CITY OF SHEBOYGAN APPLICATION FOR CONDITIONAL USE PERMIT Requirements Per Section 15.905

Narrative for Conditional Use Permit (CUP) Walmart Store 1276 (Sheboygan) Project No. 21165 3711 S Taylor Dr. Sheboygan, WI 53081

Good morning. On behalf of Walmart Stores Inc., LK Architecture, as an authorized agent, present for your consideration, a Conditional Use Permit (CUP) Application for Walmart Store 1276 located at 3711 S Taylor Dr. Sheboygan, WI.

Max/Min 6.14 N.A.

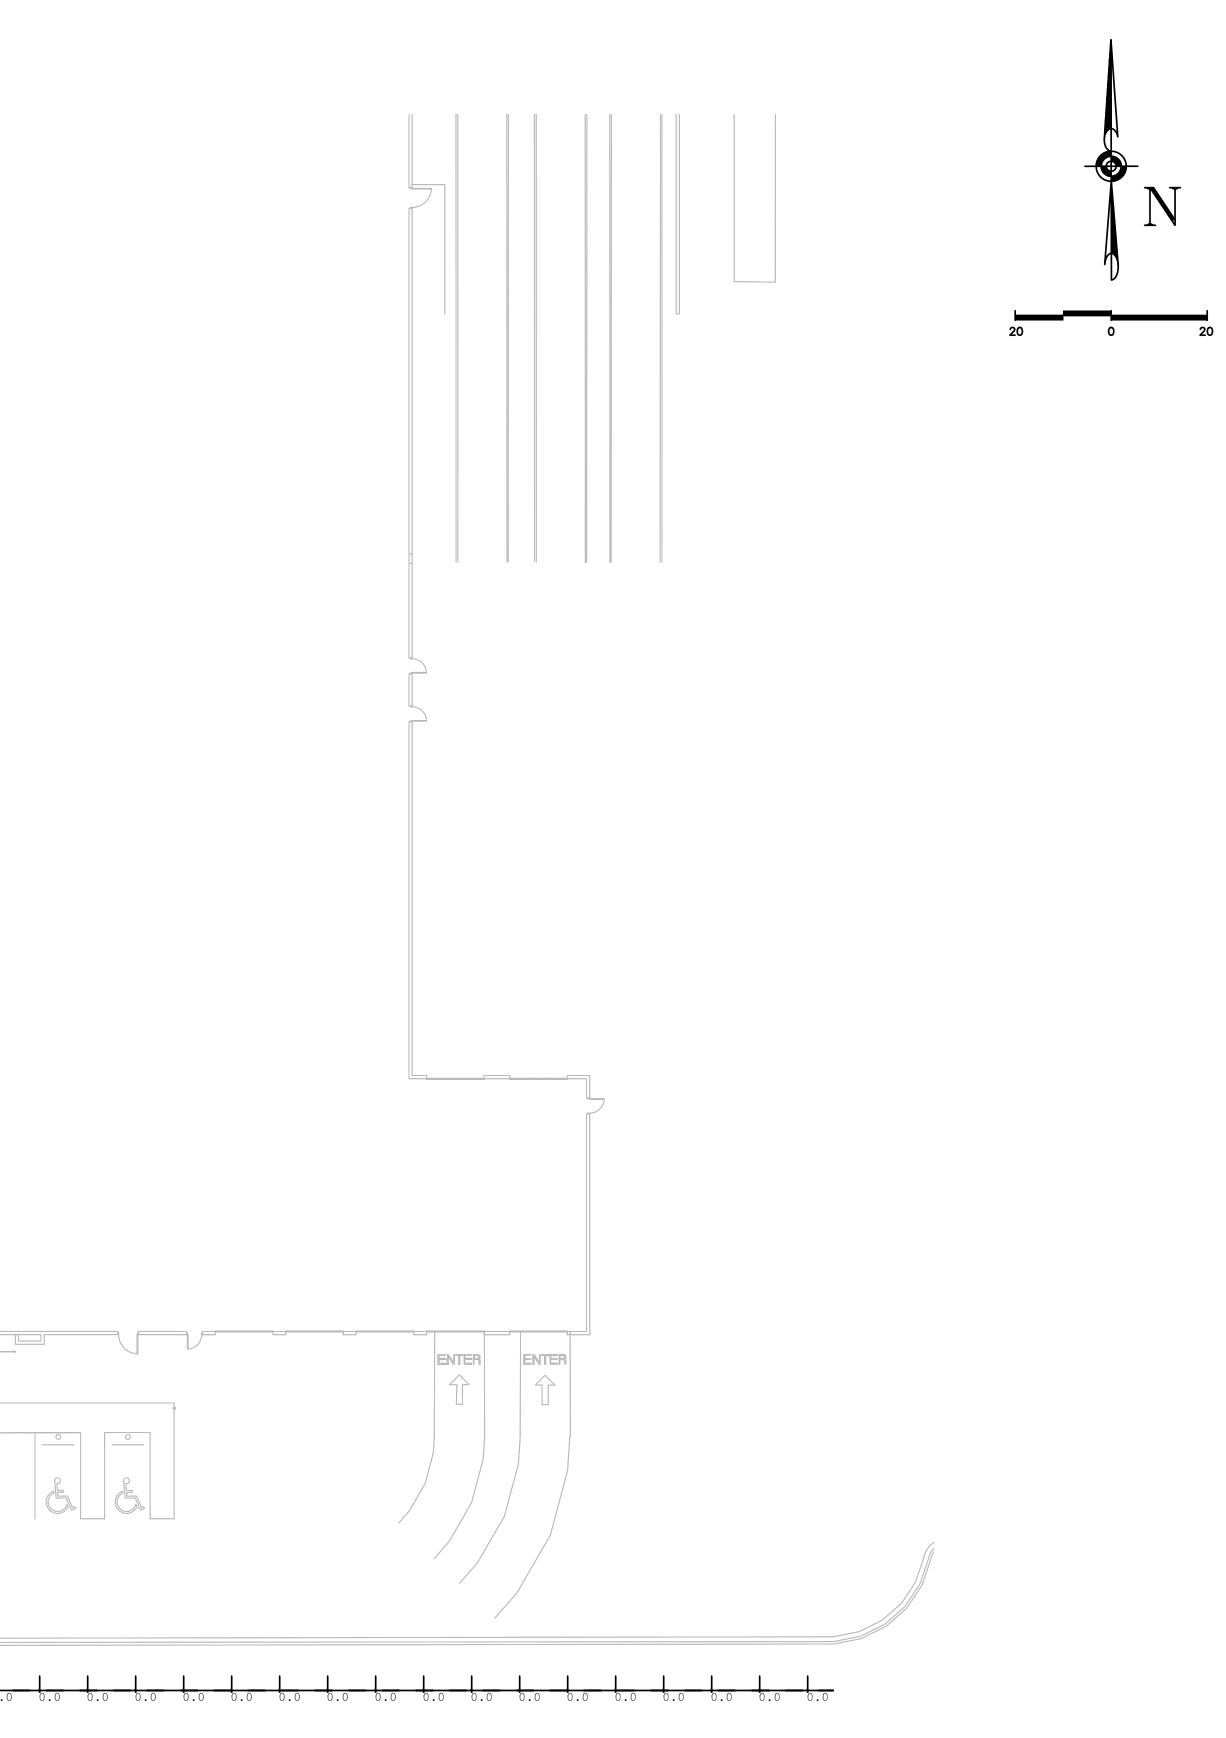
• Are you adding any additional parking lot lighting.....lighting cannot spill over onto adjacent properties, especially the area of the new pickup parking? Please provide details on new lighting poles.

Two new light poles and fixtures will be added south of the existing curb line to provide an average of 2.0 footcandles in the Pickup area. The vertical footcandles were also evaluated along the southern property line at a height of 5'. Footcandles along the property line will be 0.2 or less which is well below typical suburban requirements at property lines. Please reference exhibit (SD3 – Photometric Plan) for lighting location and (Lighting Pole Base Detail) for details.

SOUTHEAST CORNER PROPOSED CONDITION RENDERED IMAGE

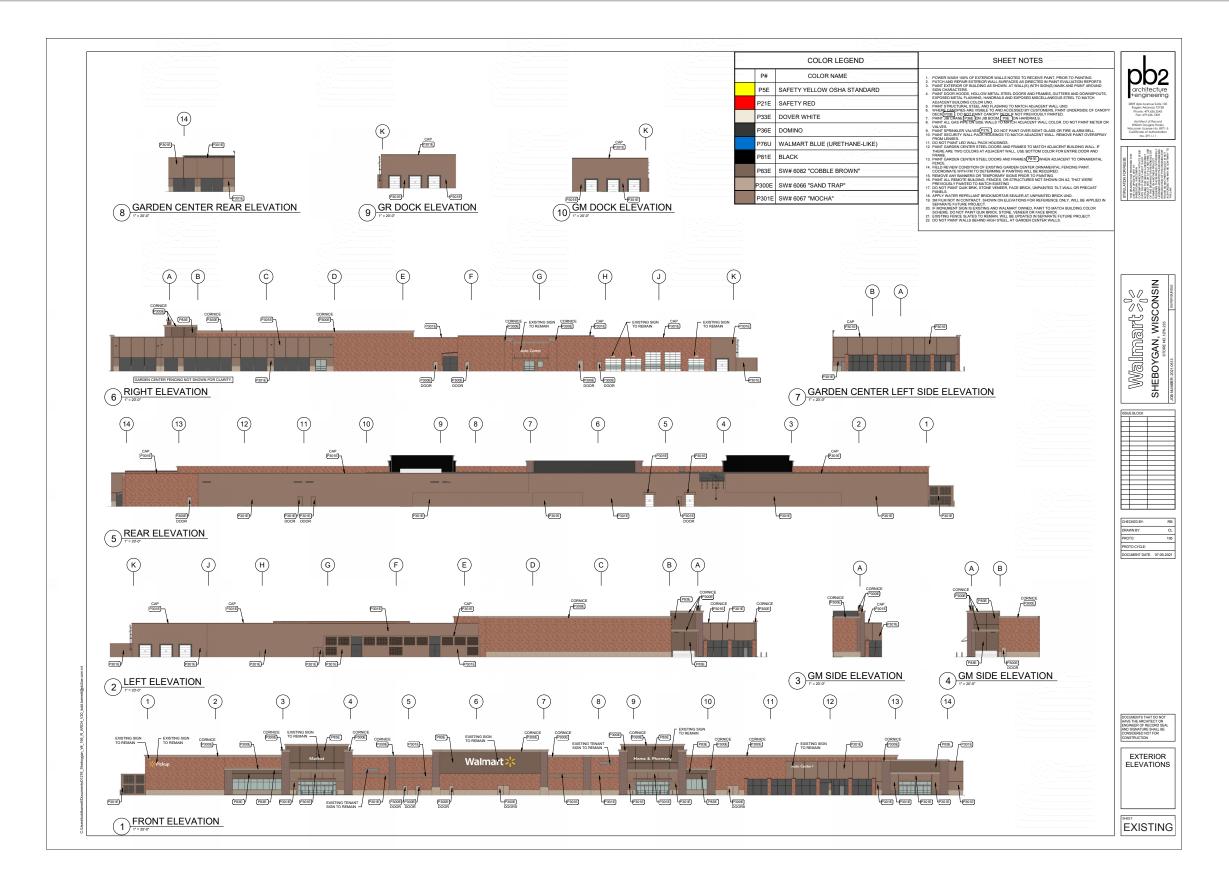
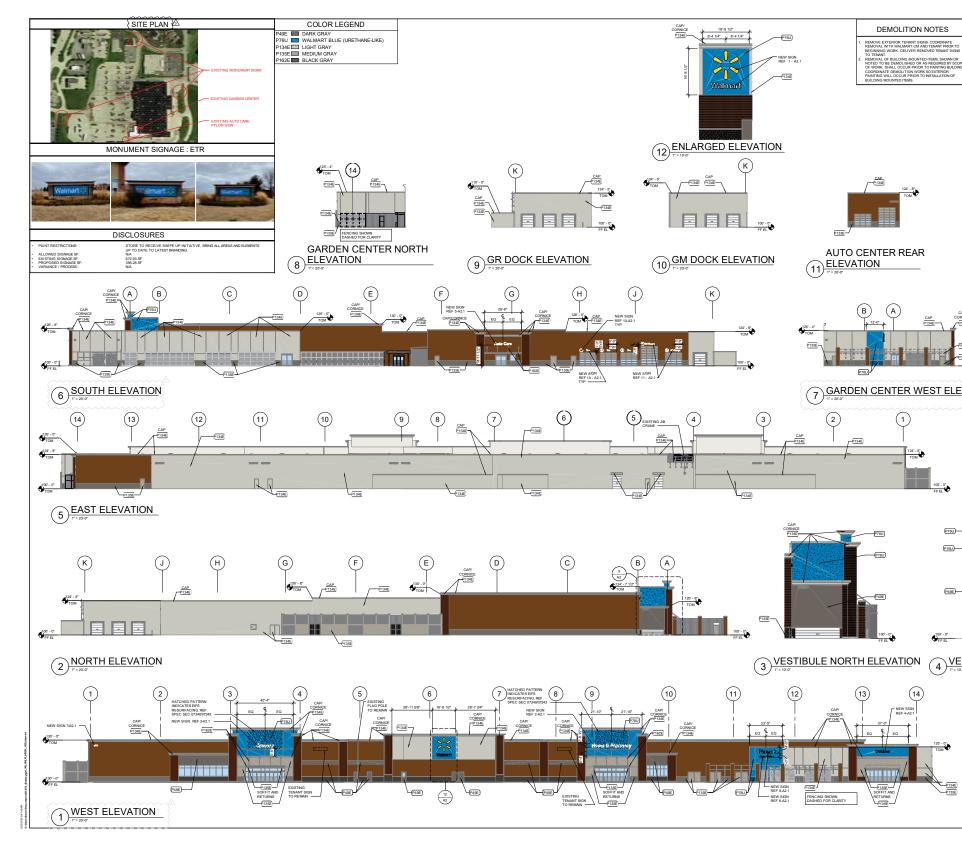
• I would also recommend including pictures from other projects so the Plan Commission can understand the project including the new Pickup area, the signage at the Pickup area, the directional signage, painting of the building, etc.

Please reference exhibit (East Side Rendered Image) for a more detailed aspects of our proposal for this project. Also refer (Decatur, IN) for picture of example project.
